DOCKET 50-255 - LICENSE DPR-20 - PALISADES NUCLEAR PLANT
SUPPLEMENTAL INFORMATION TO TECHNICAL SPECIFICATION CHANGE
REQUEST - SPENT FUEL POOL BORON CONCENTRATION

**SUPPLEMENTAL INFORMATION TO TECHNICAL SPECIFICATION CHANGE
REQUEST - SPENT FUEL POOL BORON CONCENTRATION**

**PAGE CORRECTIONS TO THE MARCH 2, 2001
TECHNICAL SPECIFICATION CHANGE REQUEST**

Figure B 3.7.16-1 (page 1 of 1)
Spent Fuel Pool Arrangement

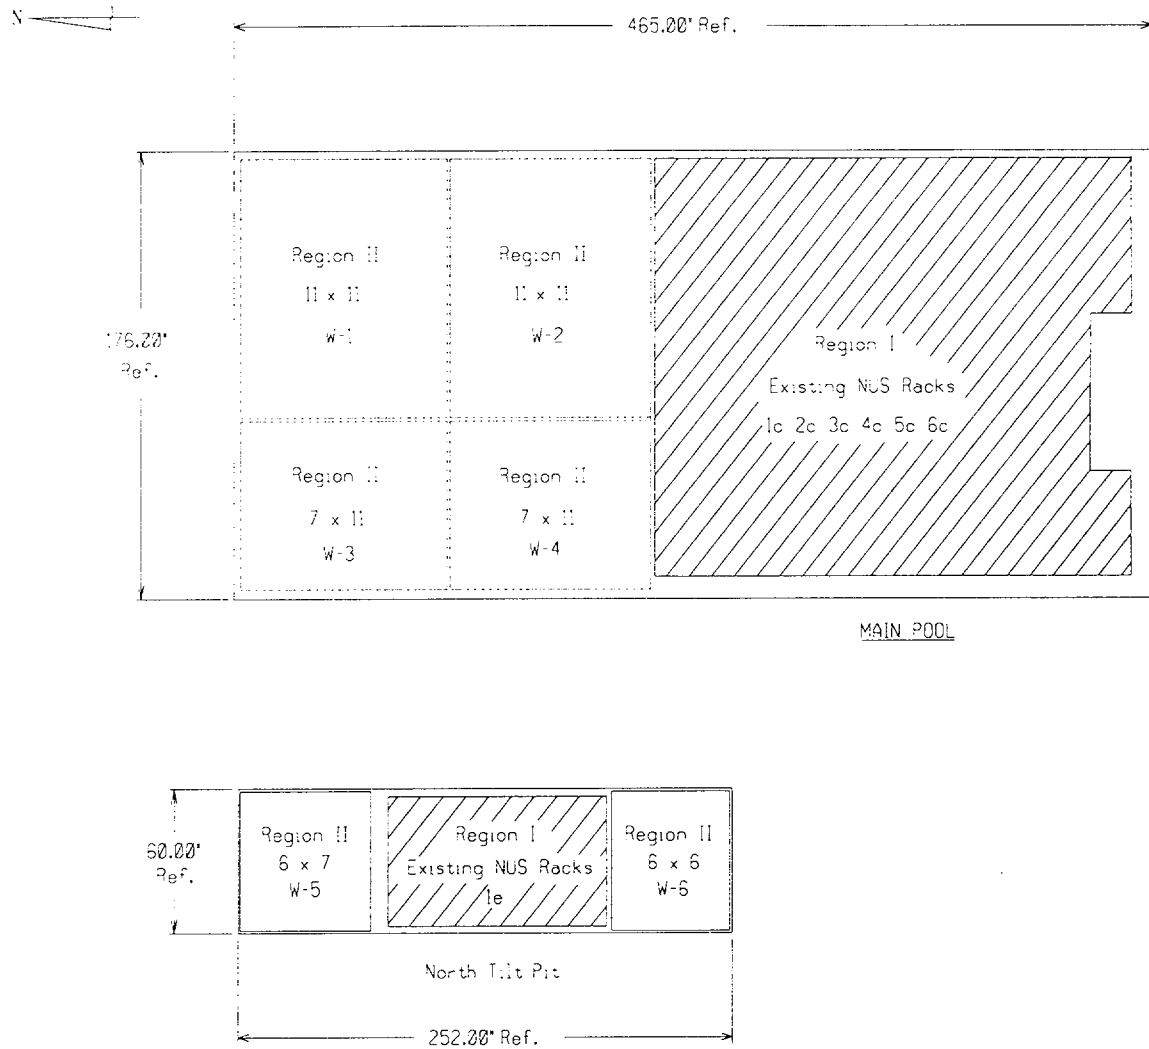
By letter dated March 2, 2001, Nuclear Management Company, LLC (NMC) submitted the subject Technical Specification Change Request (TSCR). The NRC staff requested supplemental information to facilitate their review during telephone conversations with Palisades staff members on September 12, 2001, and December 4, 2001. Attachment 1 provides this supplemental information. In addition, Attachment 2 provides page corrections to five pages contained in the March 2, 2001, TSCR. These page corrections address typographical errors and provide a more legible figure containing the Palisades spent fuel pool configuration.

4.3.1.2 The Region II fuel storage racks (See Figure B 3.7.16-1) are designed and shall be maintained with;

4.3.1.2 The Region II fuel storage racks (See Figure B 3.7.16-1) are designed and shall be maintained with;
